## Pre-Application Report

**Case Number / AMANDA No.** PRE-AP20-85 / 20-114549-PA  
**Applicant** Neighborly Ventures Inc.  
2925 River Road S, Suite 100  
Salem, OR 97302

Pre-application conference to discuss development of a 183-unit multiple family development as phase two of The Grove apartments at Fairview. Eight-four of the units are proposed on a portion of the former Fairview Training Center site located in the 4000 to 4100 Blocks of Reed Road SE and the remaining ninety-nine units are proposed to be located on a portion of the former Fairview Training Center site located at 2110 Strong Road SE.

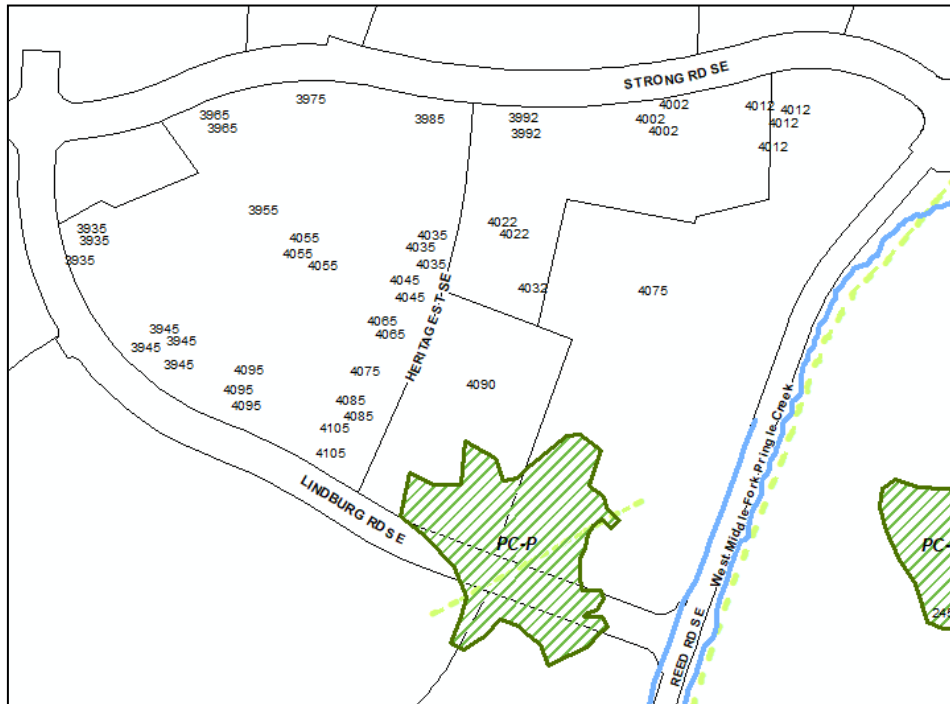
There are trees present on the subject property, including significant Oregon White Oaks. The Fairview Plan Natural Resources Inventory ([Exhibit 4](#) to the Fairview Plan master plan) identifies three significant tree stands on/adjacent to the east site (*see section of natural resource inventory map below with significant tree stands identified by white outline*).

The proposed development must conform to the tree preservation requirements of SRC Chapter 808 and the tree preservation requirements of the refinement plan.

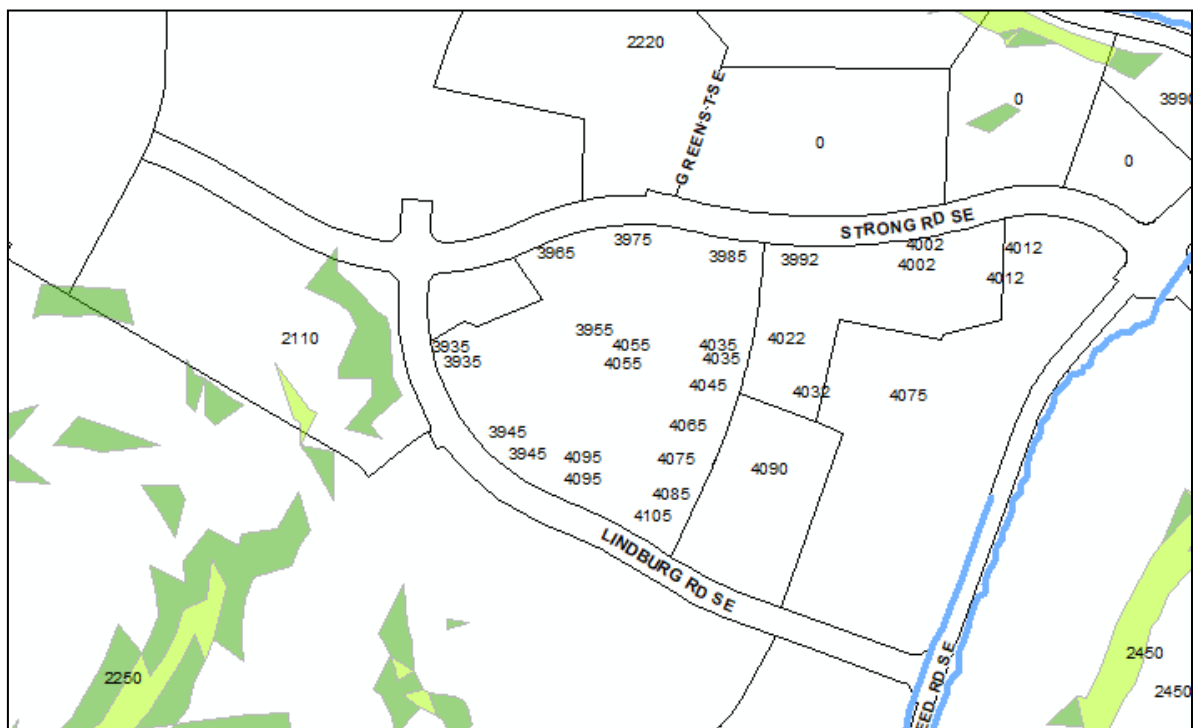
**Landslide Hazard Susceptibility (SRC Chapter 810):** According to the City's adopted landslide hazard susceptibility maps the east site does not contain any areas of mapped landslide hazard susceptibility. As shown on the below map, however, the west site does include areas of 2 to 3 points mapped landslide hazard susceptibility points. Based on the requirements of SRC Chapter 810 (Landslide Hazards), the cumulative total 4 to 5 landslide hazard susceptibility points between those associated with the land and those associated with the proposed development activity indicates a moderate landslide susceptibility risk. As such, a Geologic Assessment will be required in conjunction with the proposed development.
